Public Input No. 196 assigned to Code-Making  
Panel 4, Refer to Code-Making Panel 15

## Public Input No. 196-NFPA 70-2023 [ Definitions (100): Microgrid.... to Microgrid

<u>File Name</u>	<u>Description</u>	<u>Approved</u>
IMG_2424.jpg	Figure 517.2 Health Care Electrical Sources and Distribution Systems

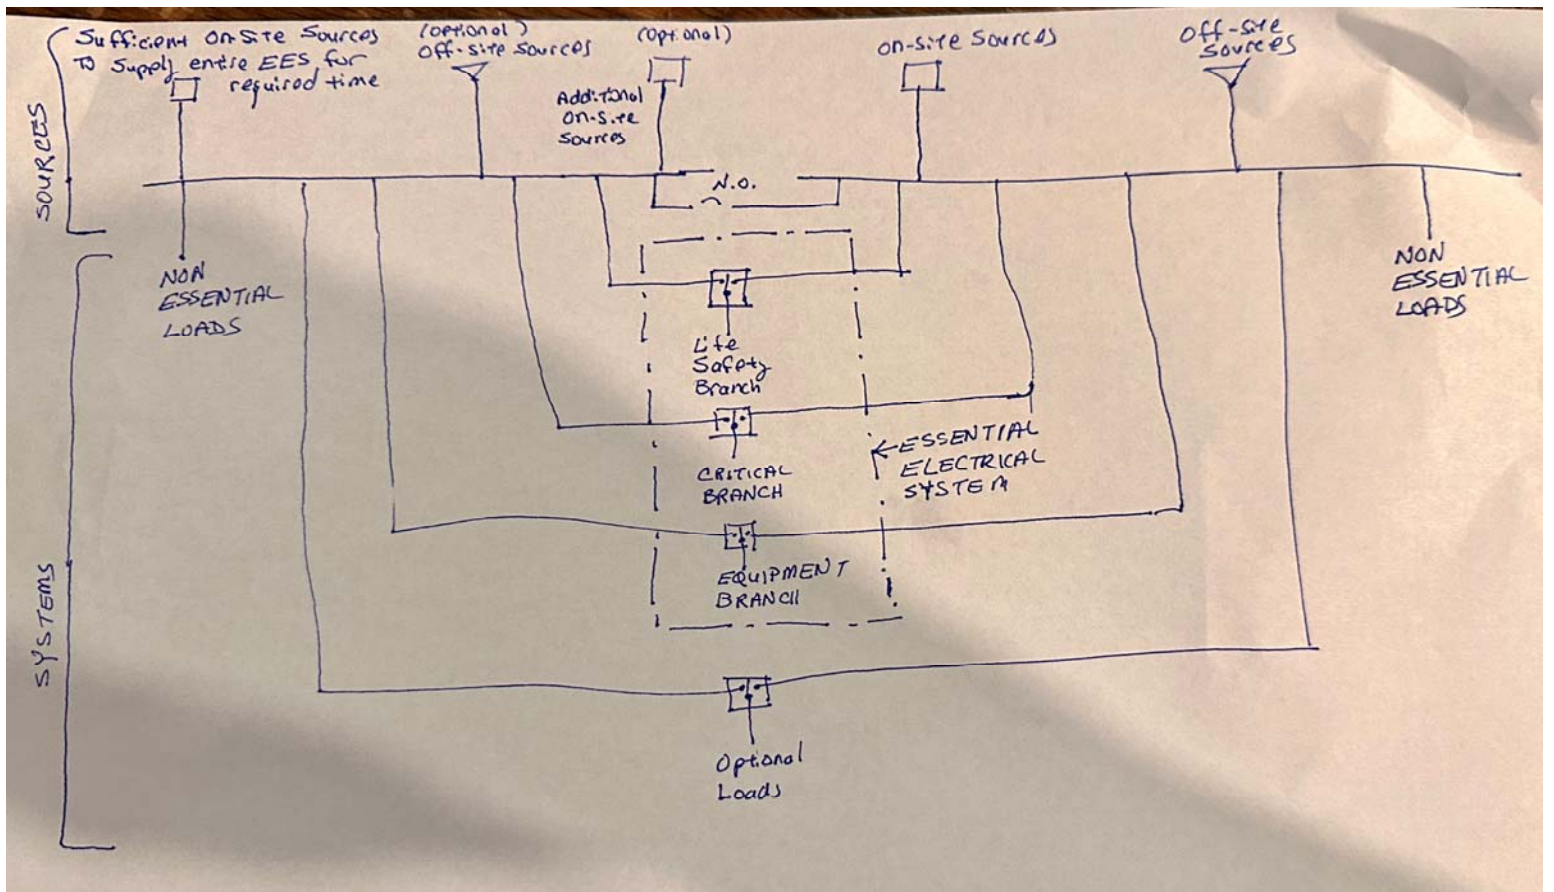
The sizing requirements of service and feeders is included in Article 220, however the concept of utilizing on-site power resources (Sources and stored energy power supply systems) appears to be a newer concept that has not been addressed directly by code. This statement clarifies the minimum requirements for the resources that feed the entire site. Related sections 517.30(A) and 517.41(A) provide minimum requirements for the sizing of resources that feed the Essential Electrical System. We recommend that this new language be added to ensure that adequate resources are provided for both the entire site electrical requirements and for the Essential Electrical System as required in 517.3(A) and 517.41(A) for the Essential Electrical System.

**Figure Informational Note Figure 517.42(B)(1) Type 2 Essential Electrical Systems (Nursing Home and Limited Health Care Facilities) — Minimum Requirement (Greater Than 150 kVA) for Transfer Switch Arrangement.**

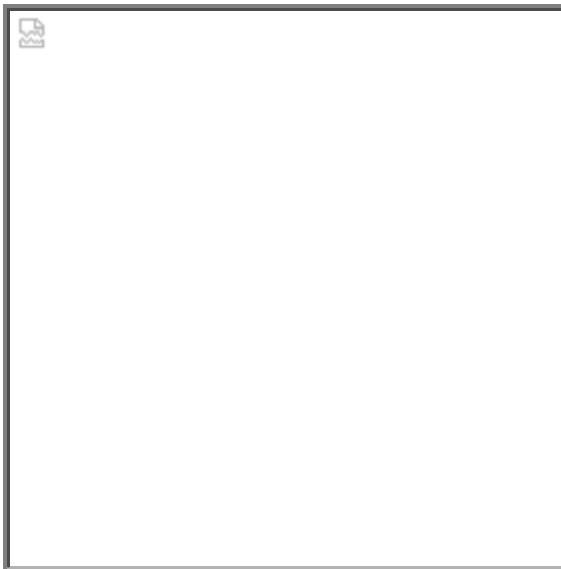
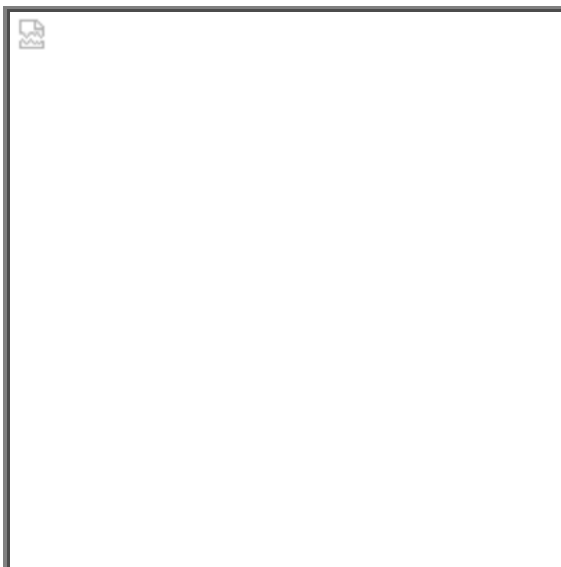
There is a potential for this to be misinterpreted. By stating that the threshold for requiring multiple transfer switches is the facilities essential electrical system load, it clarifies that the individual ATS sizing does not drive the need for multiple ATSs but the overall EES load is the driving factor. It appears that this was the intent of the code section as written. We recommend this change to avoid confusion on code interpretation. (Similar to 2109 for Hospitals)
